Certificate of Appropriateness

Property 1927 N. 2ND ST. Brewers Hill Historic District

Description of work Remove and existing small porch canopy over south wall door and construct new shed roof to

Date issued 1/10/2017 PTS ID 114195 COA

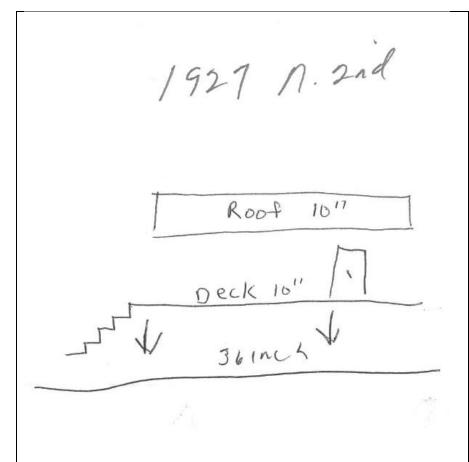
match depth of porch and extend along wall 10 feet. End detail/bracket to duplicate existing or

reuse existing.

Approximate current conditions. New 10-foot porch has already been constructed. Porch canopy shown will be rmoved and its construction details reproduced in new roof.

Roofing to be standard asphalt composition or true wood shake or shingle. Gutters, if required by code or desired by applicant is approved as half-round or K-type.
